Rezoning Transportation Analysis

Petition Number: 2019-105

Date	Description
09-16-19	First Review
10-21-19	Second Review

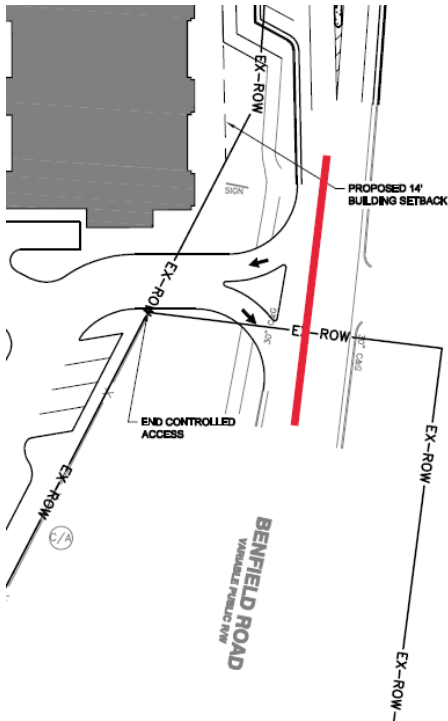
3. ~~The petitioner should revise the site plan and conditional note(s) to remove the reverse angled parking along Benfield Road and Summer Creek Lane.~~

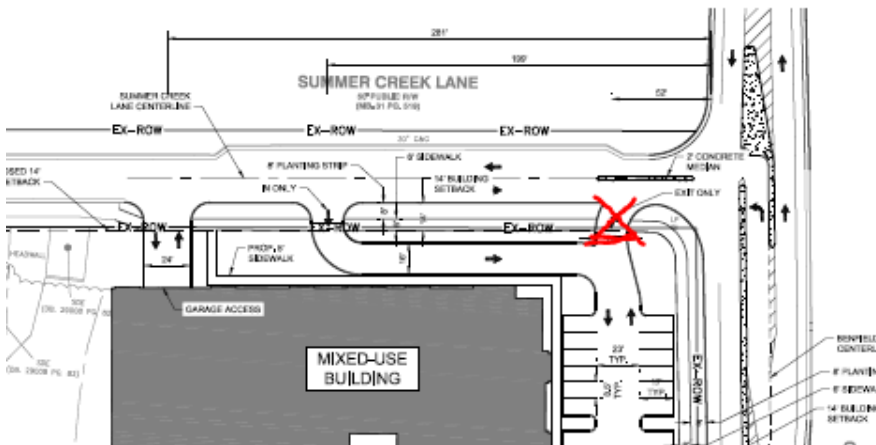
6. ~~The petitioner should revise the site plan to add a note specifying dedication and fee simple conveyance of all rights of way to the City before the site's first building certificate of occupancy is issued. CDOT requests right of way set at 2' behind back of sidewalk where feasible.~~
7. ~~The petitioner should revise the site plan to add a note specifying all transportation improvements will be approved and constructed before the site's first building certificate of occupancy is issued. The petitioner may phase transportation improvements if said improvements and phasing are explicitly described in site plan notes.~~
8. **New comment based on site plan (10/14/19):** The petitioner should revise the site plan and conditional notes to remove exit only driveway on Summer Creek Lane.
